City of
Richmond

Report to Development Permit Panel

File: DP 15-708092

Re: Development Permit for the Application by 1004732 B.C. Ltd. for a Development Permit at 6840 & 6860 No. 3 Road and 8051 Anderson Road

A-3.00

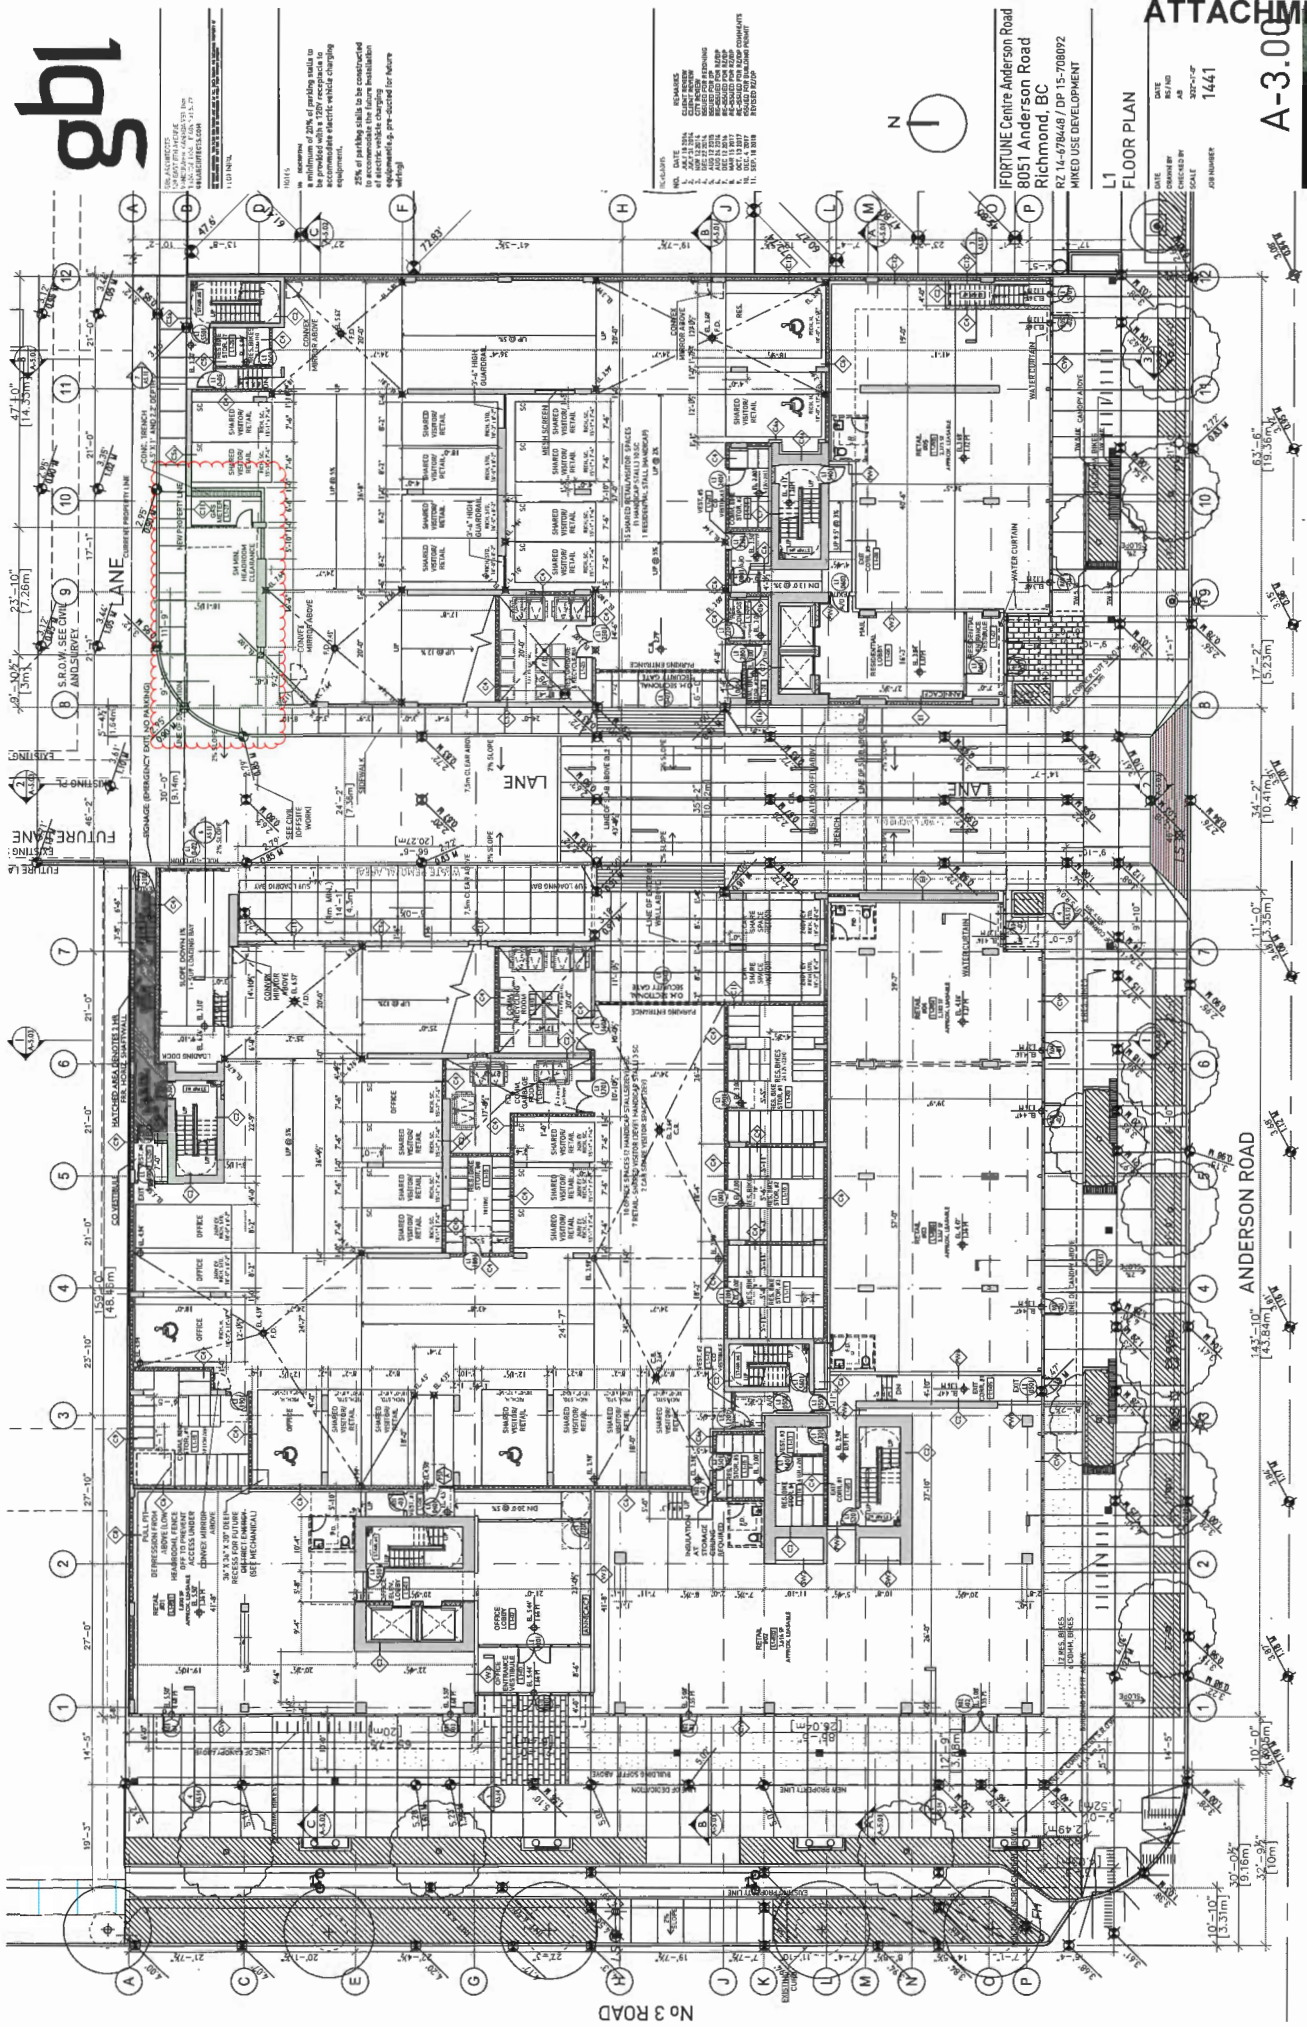
- A new turnaround area is proposed to be located in the northeast corner of the internal north-south lane, and requires that a portion of the building on the ground, mezzanine and second floors be recessed to provide adequate vehicle maneuvering area and clearance. The applicant has worked with the City's Transportation Department to ensure the turnaround area is functional and acceptable to staff.

- The proposed removal of the building area noted above results in a reduction of 11 vehicle parking spaces (two for commercial, seven for office and two for residential uses). The revised proposal still complies with the minimum required number of vehicle parking spaces as per Zoning Bylaw 8500, as the original proposal exceeded this requirement. Transportation demand management (TDM) measures that were secured as part of the original rezoning application, including end of trip facilities, car share spaces and pedestrian circulation improvements, will promote the use of alternative modes of travel to the site.
